BCA COMPLIANCE ASSESSMENT REPORT

Building Address	18 Sydney Road, Manly
Report No.	3250
Report For	InSitu Pty Ltd
Report By	Greg Murrow
Title / Company	Director Murrow Consulting Pty Ltd
Date	18 May 2022

This report provides a Building Code of Australia (BCA) compliance assessment of the proposed alterations and additions to the existing Insitu bar and restaurant within the existing multi-storey mixed use commercial and residential building at 18 Sydney Road, Manly.

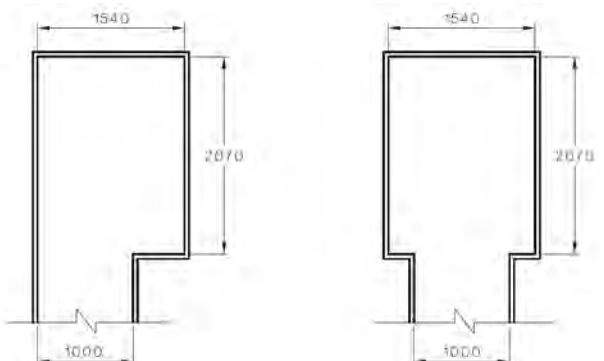
C2.9 Separation of classifications in different storeys	To be further detailed at CC stage	New floors between GF and B1 to achieve an FRL of not less than 180/180/180. Any reduction of FRLs from 180 minutes will not comply with Table 3 of Specification C1.1.
C2.10 Separation of lifts shafts	Not applicable	
C2.11 Stairways and lifts in one shaft	Not applicable	
C2.12 Separation of equipment	Not applicable	
C2.13 Electricity supply system	Not applicable	No proposed change to existing building in relation to this clause.
C2.14 Public corridors in Class 2 and 3 buildings	Not applicable	
Part C3 Protection of Openings		
C3.1 Application of Part	Noted	
C3.2 Protection of openings in external walls	To be further detailed at CC stage	<p>The new Store room doorway is a new opening in an external wall (that is required to have an FRL) and is within 3m from adjoining northern allotment boundary/easement and must be protected.</p> <p>This opening shall be either:</p> <ul style="list-style-type: none"> Repositioned to not less than 3.0m from the side boundary; or Obstructed by another part of the building (i.e. a blade wall) that has an FRL of not less than 30/-/-; and is neither transparent nor translucent as per Clause 2.1(a) of Specification C1.1. Protected in accordance with C3.4 (and if wall-wetting sprinklers are used, they are located externally); or Addressed in a Performance Solution report at CC stage.
